World Forum for Harmonization of Vehicle Regulations**Working Party on Passive Safety Provisions****Seventy-first session**

UN Regulation No. 129 (Enhanced Child Restraint Systems)**Proposal for Supplement 9 to the 01 series of amendments****Submitted by the expert from the European Association of Automotive Suppliers***

Description of Conditioning for Adjusters ~~connected to a strap~~

Figure 1
Conditioning for adjusters mounted directly on Enhanced Child Restraint Systems

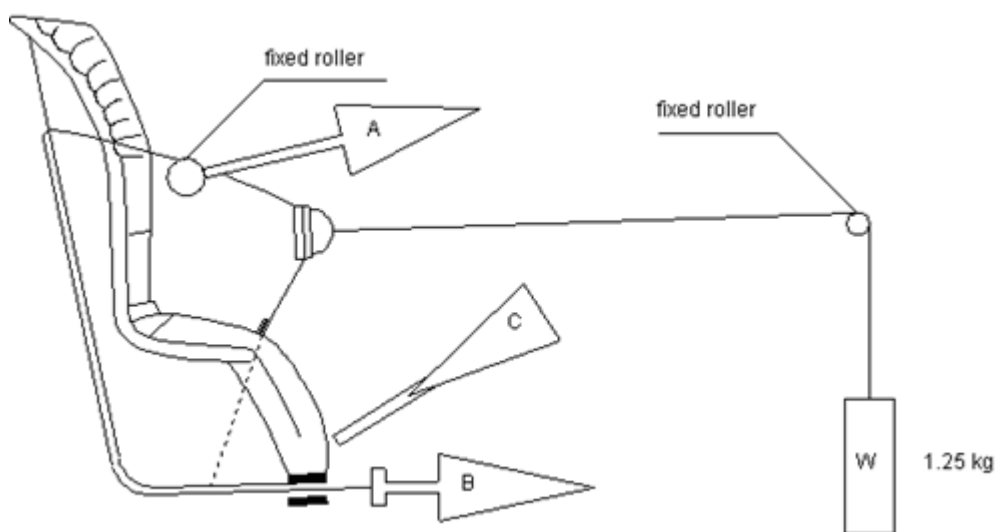
1. **Conditioning for adjusters mounted directly on Enhanced Child Restraint Systems (Figure 1)**
 - 1.1. **Method**
 - 1.1.1. With the webbing set at the reference position described in paragraph 7.2.6.1., withdraw at least 50 mm of webbing from the integral harness by pulling on the free end of the webbing.

- 1.1.2. Attach the adjusted part of the integral harness to the pulling device A.
 - 1.1.3. Activate the adjuster and pull at least 150 mm of webbing into the integral harness. This represents half of one cycle and puts pulling device A to the maximum webbing extraction position.

- 1.1.4. Connect free end of webbing to pulling device B.
 - 1.2. **The procedure of the cycle is:**
 - 1.2.1. Pull B at least 150 mm while A exerts no tension on the integral harness.

- 1.2.2. Activate the adjusters and pull A while B exerts no tension on the free end of the webbing.
 - 1.2.3. At the end of stroke, de-activate the adjuster.

- 1.2.4. Repeat cycle as specified in paragraph 6.7.2.7. of this UN Regulation.

This amendment to Annex 15 corrects an editing mistake that was made in proposals adopted at the sixty-first session of the Working Party on Passive Safety and subsequently entered into force in the 01 and 02 series of amendments to UN Regulation No. 129. Specifically, it reinstates a figure and procedure for testing adjusters mounted directly on the Enhanced Child Restraint System, which was mistakenly overwritten, instead of added to, by a figure and procedure for testing adjusters connected to a strap.

Figure 2
Conditioning for adjusters connected to a strap (not directly mounted on Enhanced Child Restraint Systems)

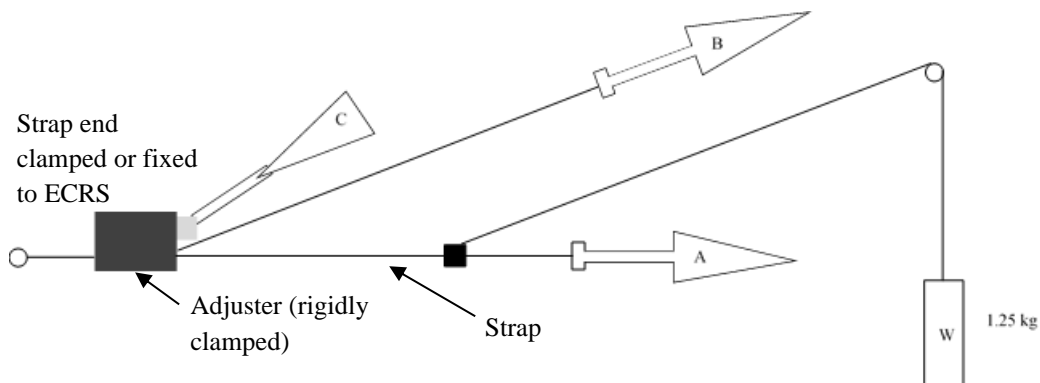
2. Conditioning for adjusters connected to a strap (not directly mounted on Enhanced Child Restraint Systems) (Figure 2)
